Product/Process Change Notice (PCN)

PCN #:
PCN_WE_RJ45LAN_20170405_7499XXXXX
Product Affected: WE-RJ45 LAN

PCN Date: 2017-04-25

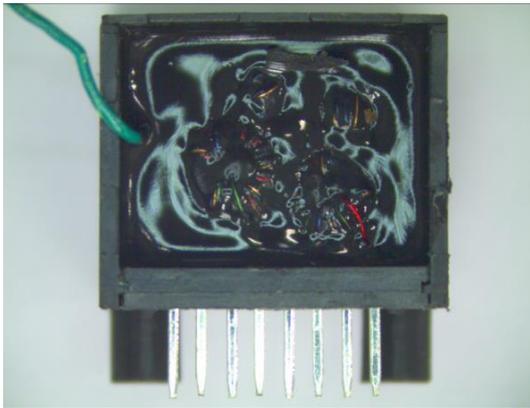
Due to product optimization, the toroid cores inside the RJ45 housing will be placed and soldered inside a plastic header. The dielectric rating for the SMT capacity will also be changed.

With the new header, it's more reliable in production to connect the isolated wire to the inner circuit board.

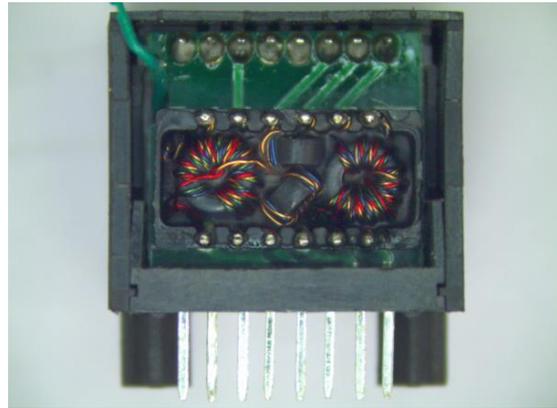
On current parts, the toroid cores are soldered and glued on top of the inner circuit board. For the new parts the cores are soldered and glued inside a plastic header, which is soldered on top of the inner circuit board.

The dielectric rating for the SMT capacity will be changed from 1500Vrms/1 min. to 2250VDC/1 min.

Betriebstemp. / operating temperature: -40°C - +85°C
Hochspannungsprüfung / Hipot test: 2250VDC 1min.
Geeignet für 10/100Base-TX gemäß IEEE 802.3u /
Compliant with IEEE 802.3u for 10/100Base-TX-Applications
Auto MDIX fähig / Auto MDIX capable
